SAFETY EVALUATION BY THE OFFICE OF NUCLEAR REACTOR REGULATION  
RELATED TO REQUEST FOR RELIEF FROM STOP VALVE CONTROL AND INTERLOCK  
REQUIREMENTS OF SECTION III, ARTICLE 9, OF THE 1968 EDITION  
OF THE ASME BOILER AND PRESSURE VESSEL CODE

PACIFIC GAS AND ELECTRIC COMPANY

DIABLO CANYON POWER PLANT, UNITS 1 AND 2

DOCKET NOS. 50-275 AND 50-323

FIGURE 1

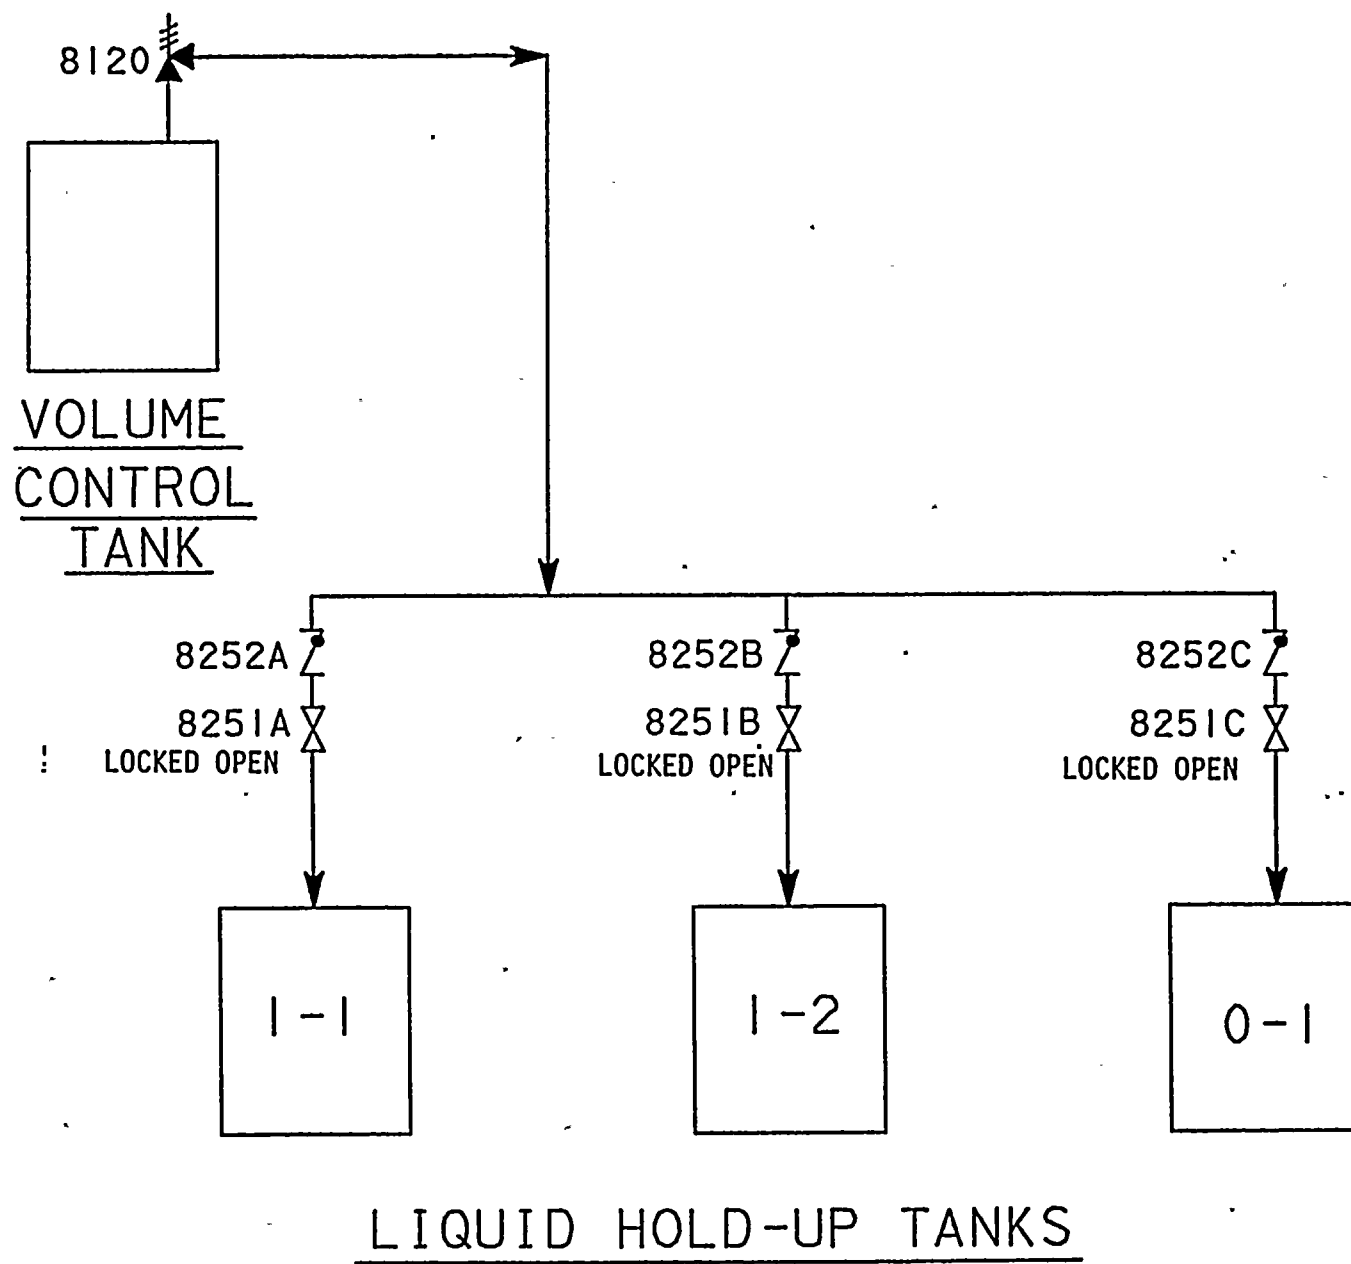
Figure 1 shows a schematic of the VCT block valve/relief valve configuration, which is typical for both units. The block valves are locked open in the relief valve CVCS-1-RV-8120 and CVCS-2-RV-8120 discharge paths. Each relief valve provides overpressure protection for VCT 1-1 and VCT 2-1. The relief valves discharge to one of three available liquid holdup tanks (LHUTs) that contain the radioactive gas or liquid released. The purpose of the block valves is to (1) isolate individual LHUTs for personnel safety during maintenance, (2) allow processing of individual LHUT contents without uncontrolled discharges into an LHUT, and (3) allow individual LHUT testing without incapacitating the entire system or VCT overpressure protection.

The VCT provides surge capacity to accommodate programmed pressurizer level changes. The VCT functions are not safety related. Relief valve CVCS-8120 discharges to one of three LHUTs to preserve VCT integrity if the CVCS malfunctions. Block valves CVCS-8251A, B, and C are installed between the relief valve and the three parallel discharge lines to the LHUTs. The relief valve does not have an active safety function and is not required to actively operate during or following an accident to perform a nuclear safety function.

The possibility of concurrent inadvertent closure of block valves 8251A, B, and C during power operation is extremely low, due to the licensee's previously described administrative controls. Nonetheless, if all three block valves are inadvertently closed at the same time during power operation, the pressure relief function of relief valve CVCS-8120 would be defeated. Without adequate relief capability, overpressurizing the VCT could potentially result in failure and release of RCS primary system liquid and gases to the auxiliary building.

Chapter 15 of the updated final safety analysis report (UFSAR) analyzes VCT passive failure (rupture) consequences. This analysis demonstrates that a complete VCT failure will not result in unacceptable radiological consequences. The FSAR Chapter 15 VCT rupture analysis bounds potential consequences of VCT rupture due to inadvertent VCT block valve closure.

Block valves CVCS-1-8251A, B, C and CVCS-2-8251A, B, and C are locked open. Operating Procedure (OP) B-1B:II, "Boron Recycle

System - Liquid Hold-Up Tank Alignment for Plant Heat-Up," indicates that these valves are locked open.

OP B-1A:IX, "CVCS - Alignment Verification for Plant Startup," requires that at least one block valve in each unit be locked open when the VCT is aligned for service. This assures that the VCT flowpath to the LHUT is maintained.

FIGURE 2

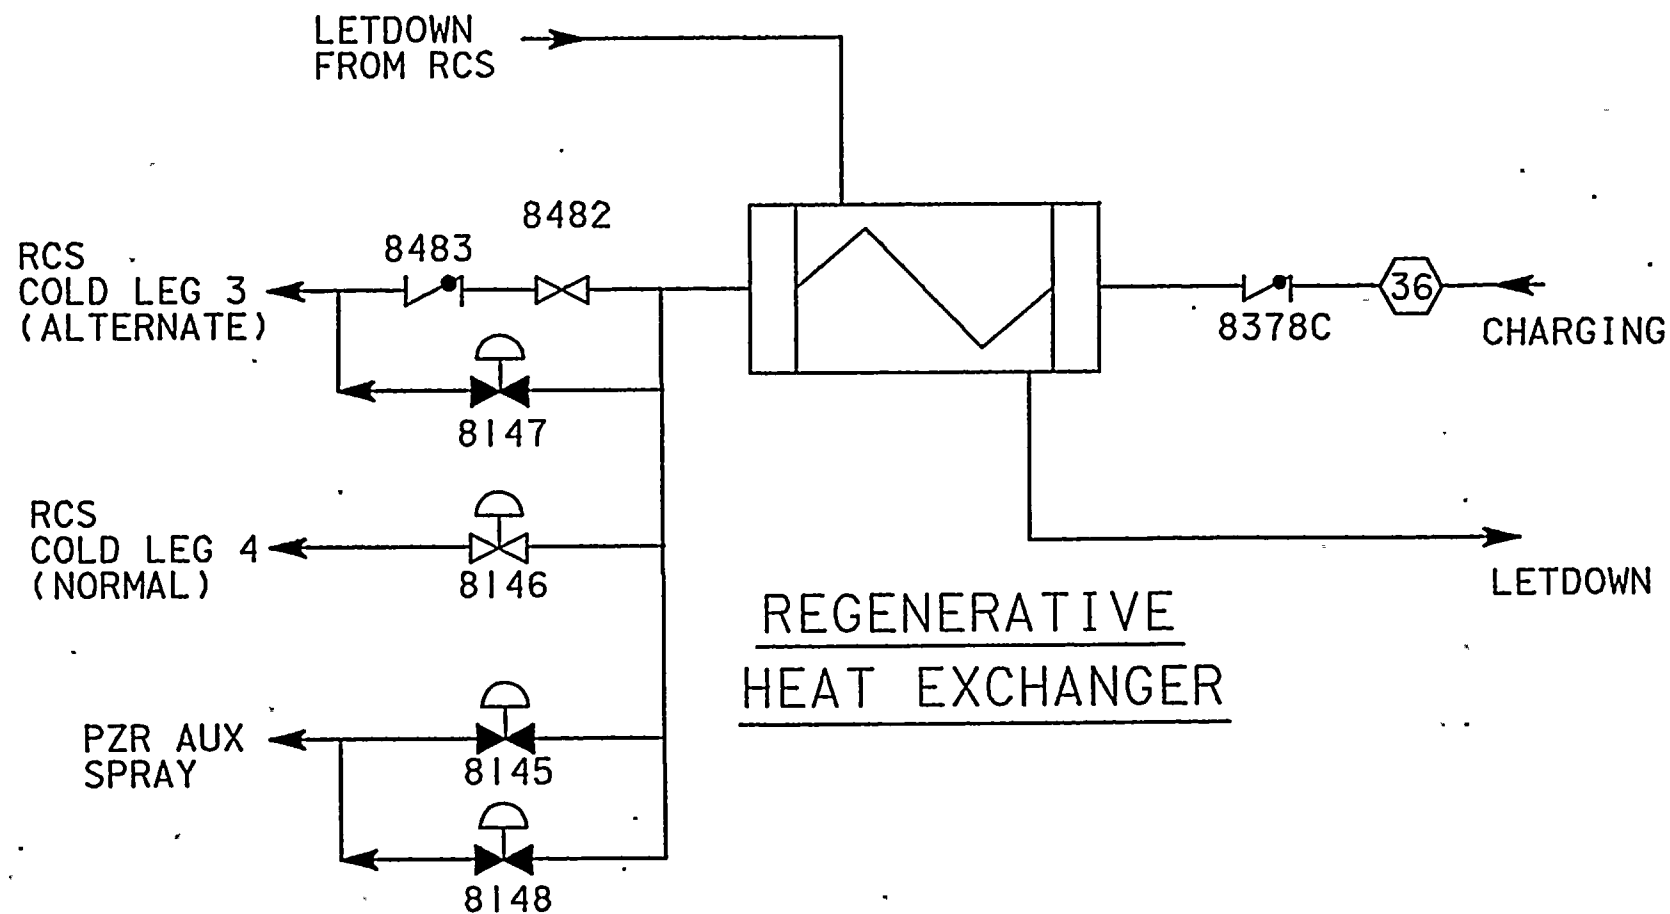
Figure 2 shows a RHE block valve/relief valve configuration schematic that is typical for both units. The block valves are in the discharge path of spring U-loaded thermal relief check valves CVCS-1-8483 and CVCS-2-8483. Each relief valve provides overpressure protection for RHE 1-1 and RHE 2-1 if the CVCS malfunctions. Each relief valve discharges to the reactor coolant system (RCS). The purpose of the block valves is to facilitate RHE maintenance.

charging side of the heat exchanger can be relieved to the RCS through thermal relief (spring-loaded) check valve CVCS-8483. This preserves RHE integrity if the system malfunctions. Block valve CVCS-8482 is installed upstream of relief valve CVCS-8483. The relief valve does not have an active safety function and is not required to actively operate during or following an accident to perform a nuclear safety function.

The possibility of inadvertently closing block valve CVCS-8482 during power operation is extremely low, due to the administrative controls earlier described. Nonetheless, the pressure relief function of spring-loaded check valve CVCS-8483 would be defeated if block valve CVCS-8482 is inadvertently closed during power operation. Without adequate relief capability, overpressurizing the RHE could potentially result in failure and a release of RCS primary system liquid and gases to the containment.

Chapter 15 of the UFSAR evaluates small-break loss-of-coolant accidents (LOCAs). The limiting case is a 4-inch-diameter pipe break in the cold leg. A postulated RHE rupture would result in less RCS fluid loss to the containment since the charging and letdown lines to and from the RHE are 3 inches in diameter and operators can isolate the RHE from the RCS. Therefore, small-break LOCA analysis described in Chapter 15 of the UFSAR envelopes this scenario.

Block valves CVCS-1-8482, and CVCS-2-8482 are located in a locked vault inside the containment biological shield. This area is highly controlled and is not accessible during power operation.
